**SUSITNA  
HYDROELECTRIC PROJECT**

FEDERAL ENERGY REGULATORY COMMISSION  
PROJECT No. 7114

**ALASKA POWER AUTHORITY  
COMMENTS  
ON THE  
FEDERAL ENERGY REGULATORY COMMISSION  
DRAFT ENVIRONMENTAL IMPACT STATEMENT  
OF MAY 1984**

**VOLUME 2B  
TECHNICAL COMMENTS  
-AQUATIC RESOURCES**

FIGURE 1

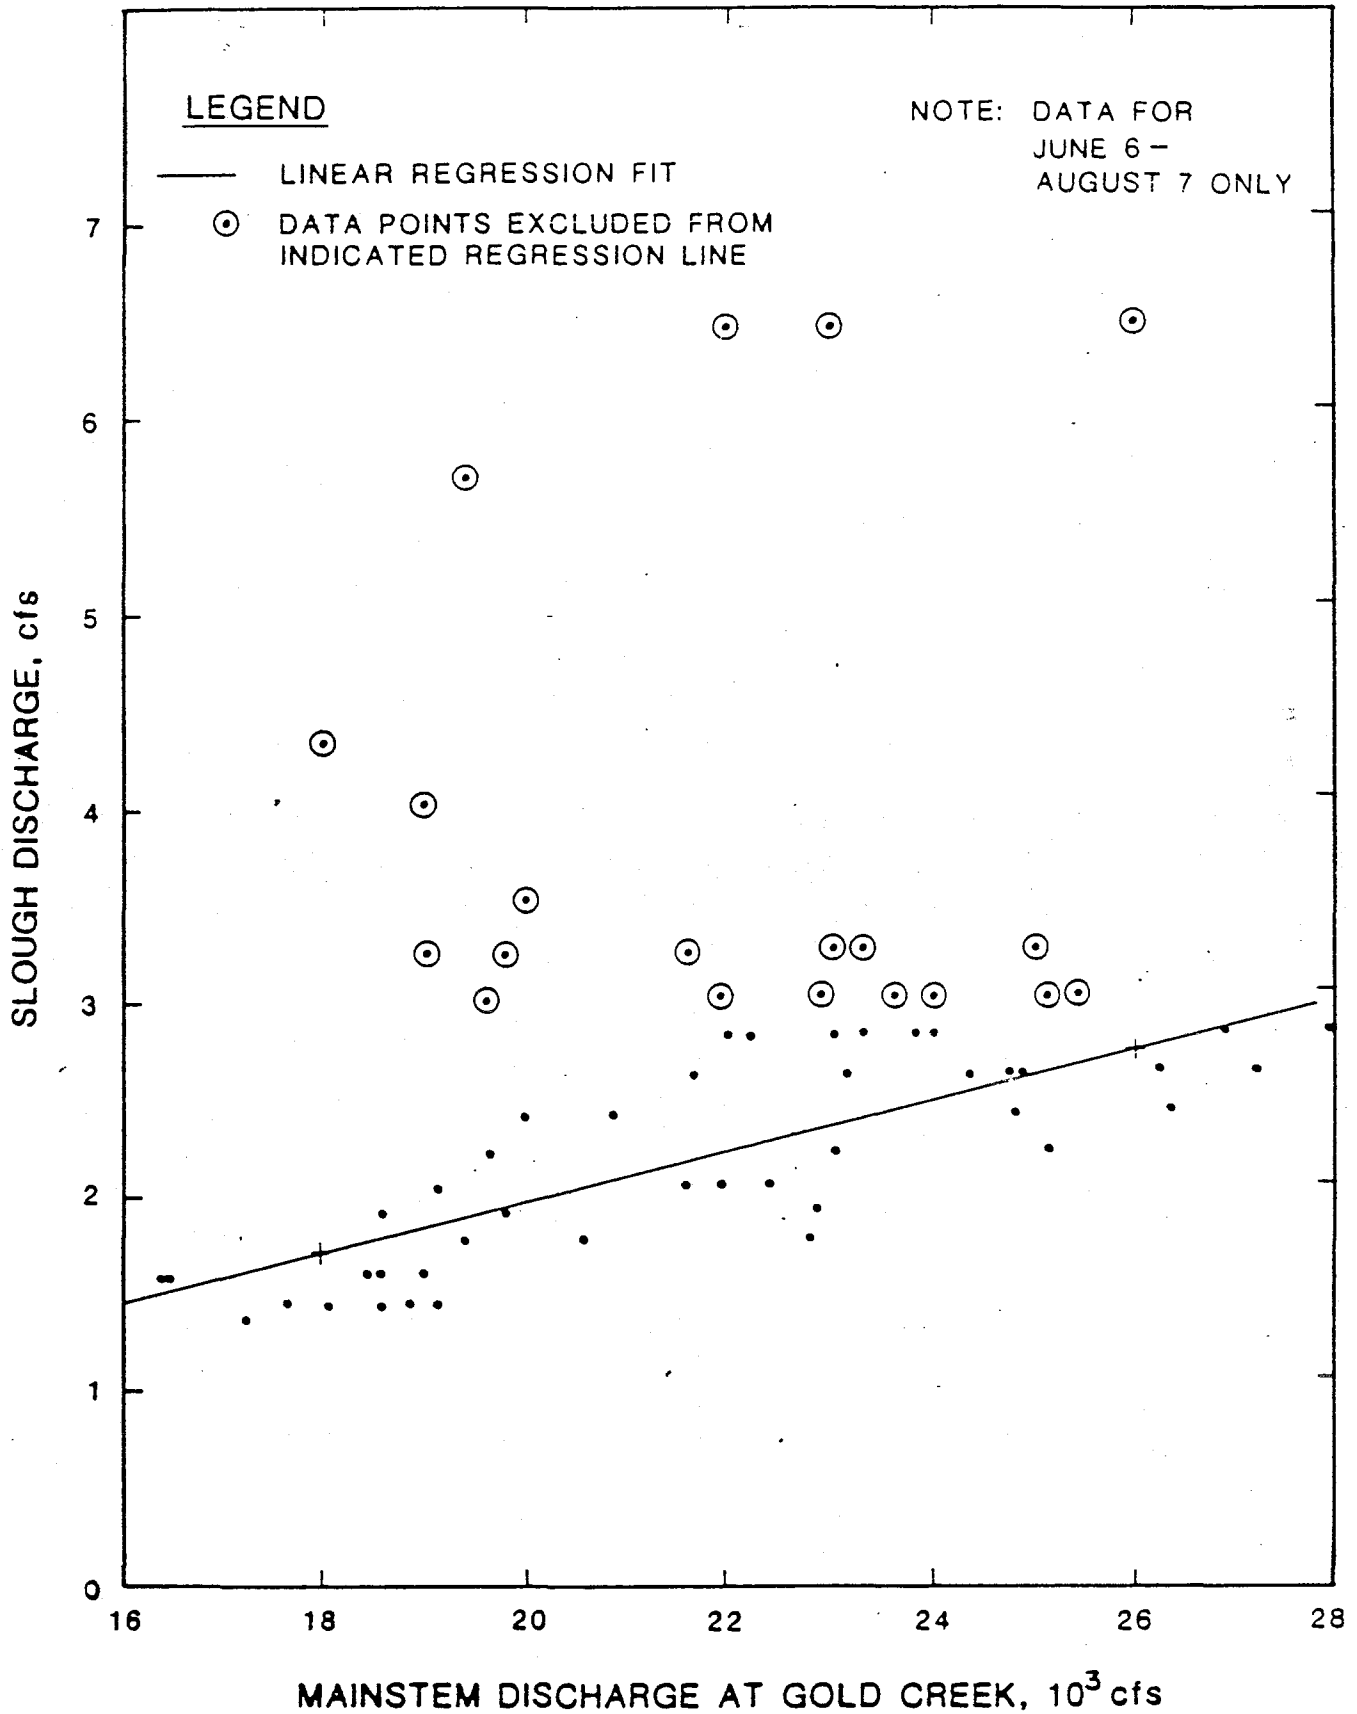
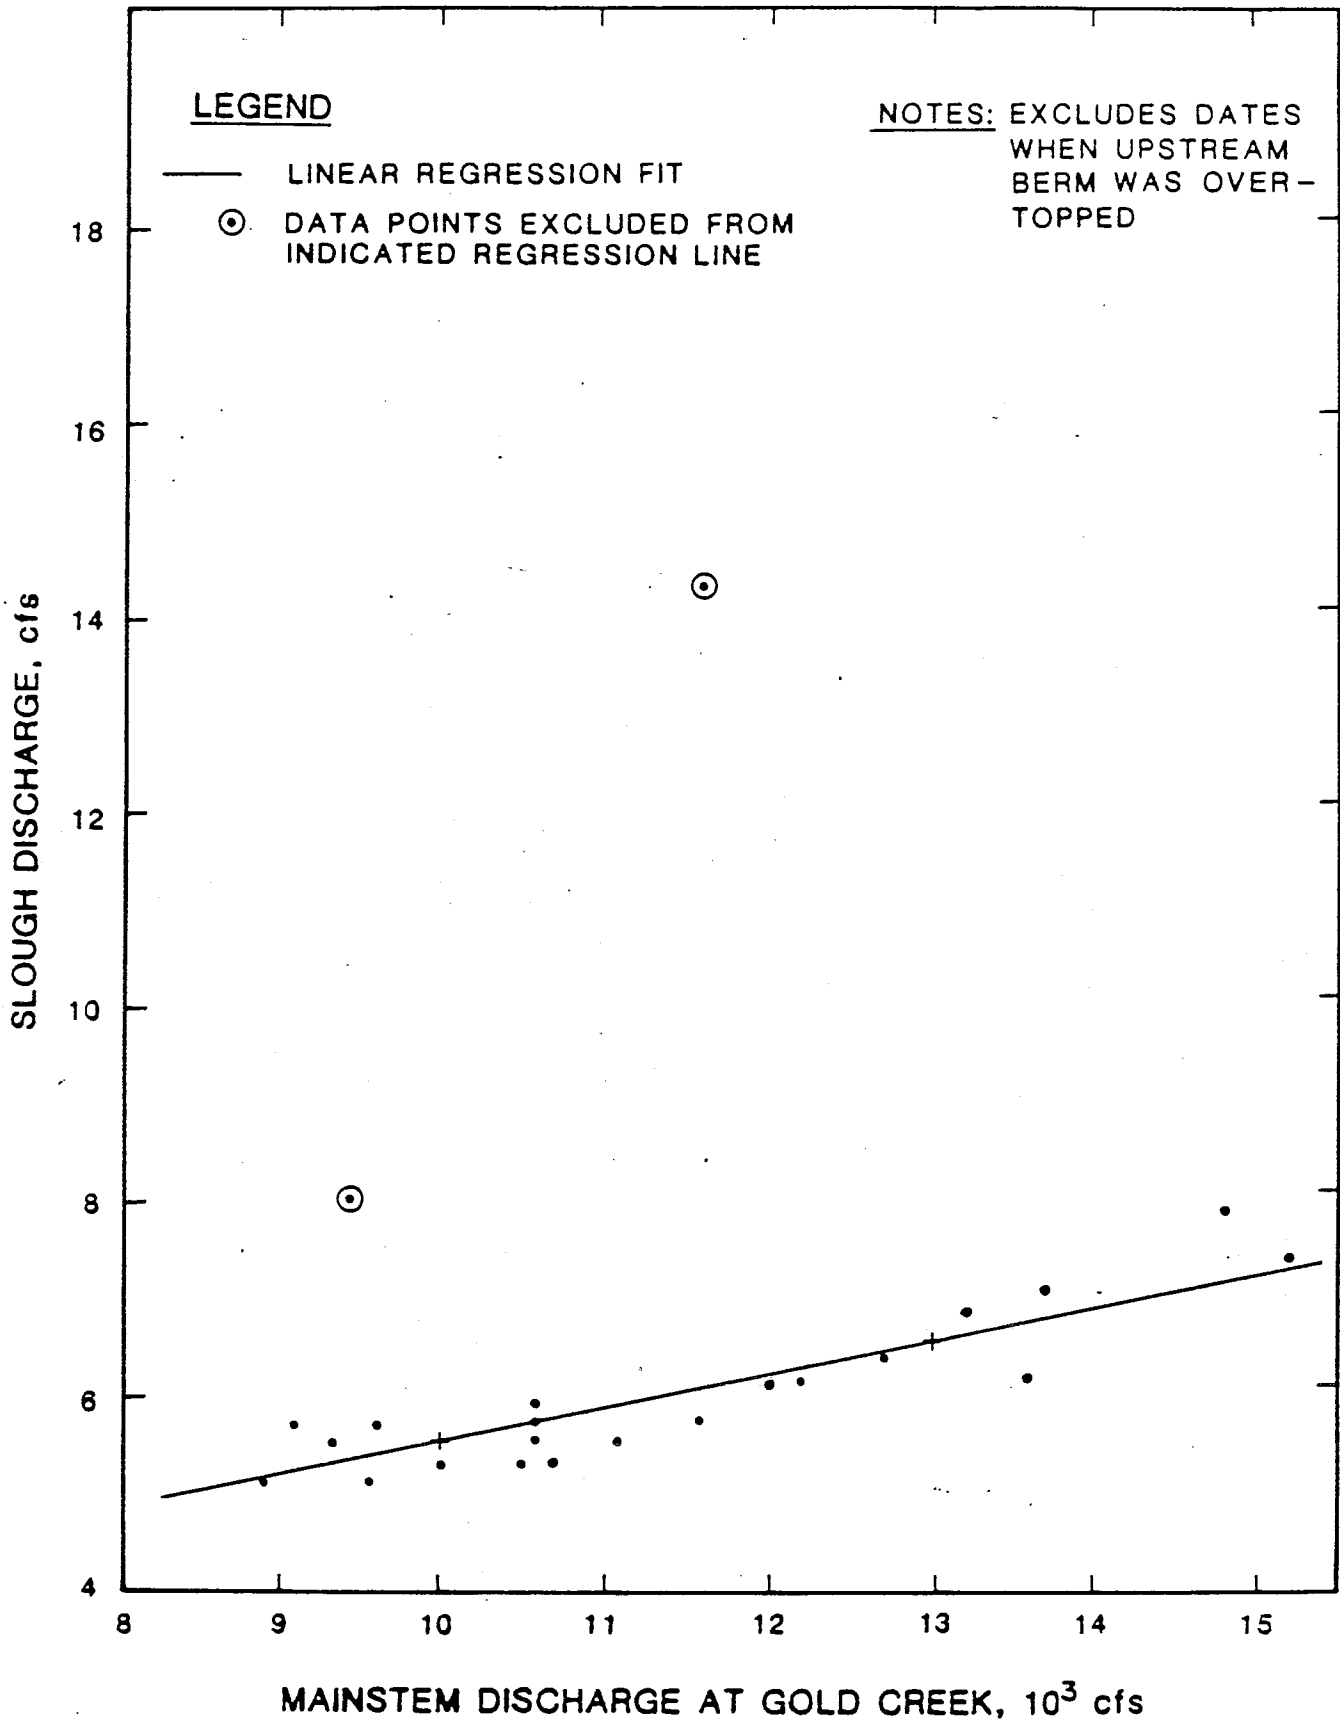
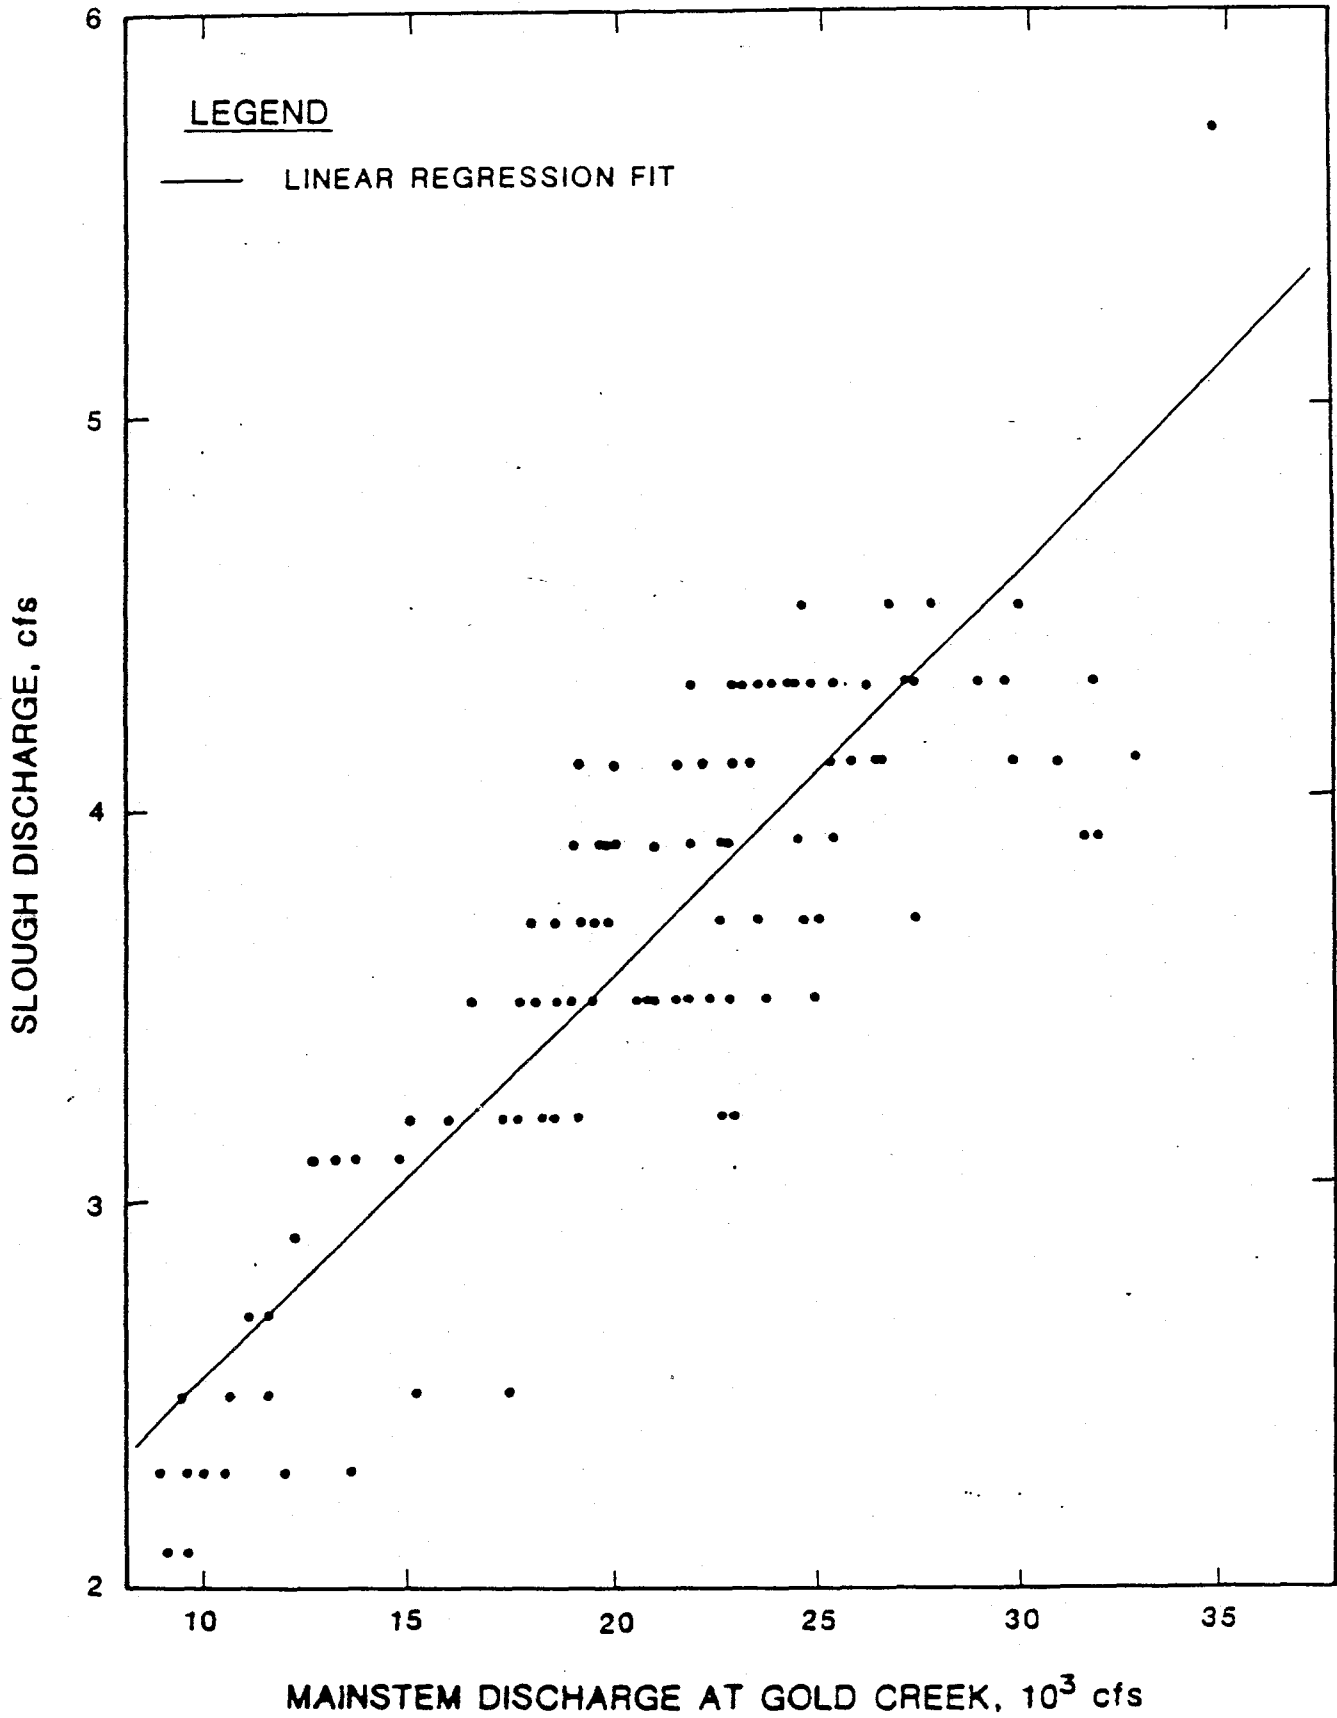
TECHNICAL COMMENT: It has been possible to isolate periods when overtopping of upstream berms by mainstem water levels and local runoff into the sloughs from tributaries and rainfall do not contribute significantly to slough flow (Appendix VII - Slough Geohydrology Studies). Using statistical analyses, inferences can be drawn of the relationships between mainstem discharge and the apparent groundwater upwelling in the sloughs for these periods. The derived relationships for Sloughs 8A, 9 and 11 are shown on the attached Figures 1 through 3, which are from Appendix VII of this document.

Slough 9 is subject to overtopping at discharges in excess of 16,000 cfs (ADF&G 1984c). Therefore, the relationship shown in Figure 2 is based solely on those points for which mainstem discharges were less than 16,000 cfs at Gold Creek. Two points were not considered in the analysis. It is possible these represent local runoff from storms.

Based on the available data and analyses, it appears the relationship between slough discharge and mainstem discharge obtained for Slough 11 is most representative of the behavior of the groundwater upwelling due to mainstem infiltration. Similar relationships would be expected of other sloughs, however, the slopes and intercepts would vary. A chart has been prepared (Figure 4) showing the simulated groundwater upwelling at Slough 11 for natural, Watana and Watana/Devil Canyon conditions for the period May 1982 to April 1983. This figure is based on the relationship between mainstem flow and slough upwelling shown in Figure 1.
